### Concerns on the lack of consistent and reliable information with a limited forecast on the future Hazard Mitigation:

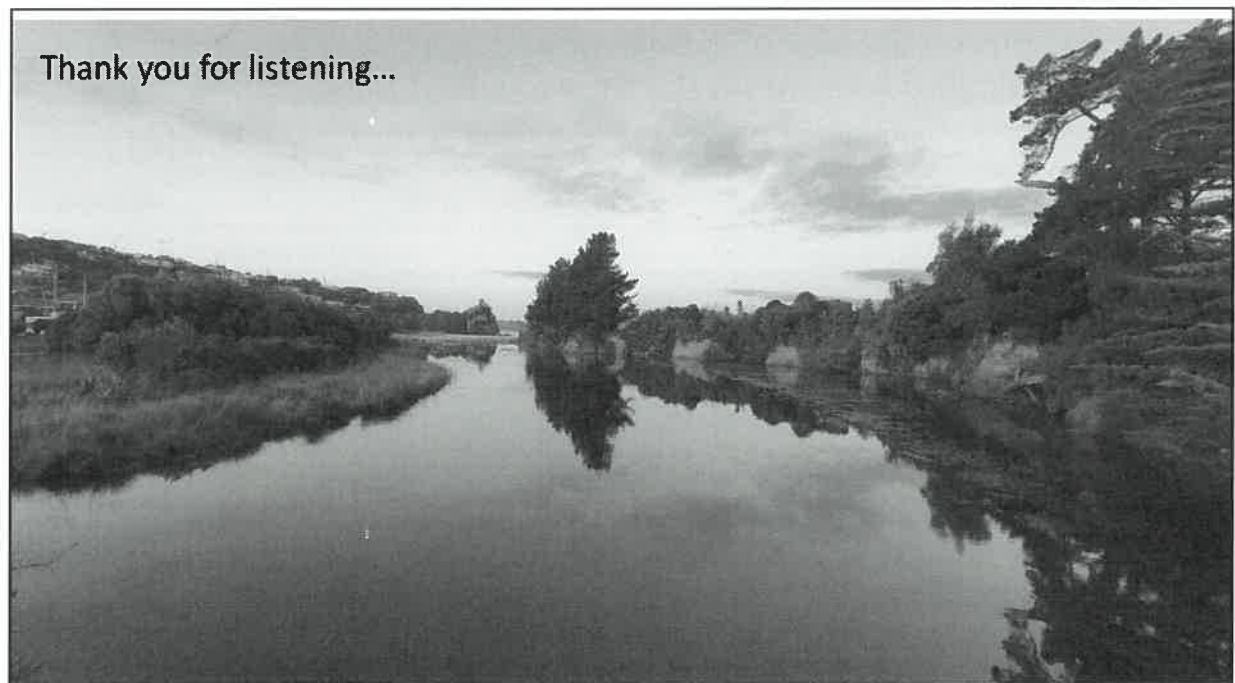
- Loess dispersive nature and highly erodibility, with a limited volume available after site clearance and organic's separation. Lime modification of loess increases durability and constructability characteristics but can affect the permeability. Effect of leachate on lime and potential for degradation of electro-chemical bond or if use high % lime the 'cementing' effect.

- Liner formed of a natural clay source typically constructed wet of the optimum moisture to increase the 'puddle' effect (makes it more deformable but still responds to compactive effort). Using lime negates the beneficial method to build an impervious liner.

- HDPE or GCL Liners have a warranty are limited in timeframe and under specific operational and ongoing maintenance conditions. Reliance on under-liner drainage and external surface monitoring to determine leakage and 'plume' direction.

- Surficial Henley Breccia erodibility, variable permeability, suitability for reuse as capping material or in a zoned liner. Land stability and effects of the shallow groundwater table on the proposed steep excavations / road cuttings.

- Deep seated landslide failure not modelled yet but the terrain indicates this has occurred. Underlying less weathered Henley Breccia drilling indicates appear to either be from faulting or shear / crush zones from large scale landsliding. The deeper low permeability layer and colour changes in the geology presents a combination of confined and higher flow aquifer with the likelihood of well developed preferential seepage pathways.

- Deeper groundwater table with vertical recharge has a seepage time from site to reach either the Taieri (~4.1km) 120-1300years or the Pacific (~3.1km) 95-1000years (*simplified calculation based upon the limited pumping tests information*).

- The initial seismic hazard recognises the site is located between two 'active' faults The 'Titri' and 'Akatore' with 0.5g ground accelerations, however the block (uplift or downthrow) displacement is as yet undefined.

- Do the geology, groundwater along with the 'active' faults or ancient landsliding present a future hazard post de-commissioning.

=> in light of these geological and engineering uncertainties does it warrant developing a 'greenfield site landfill at the top of the catchment?
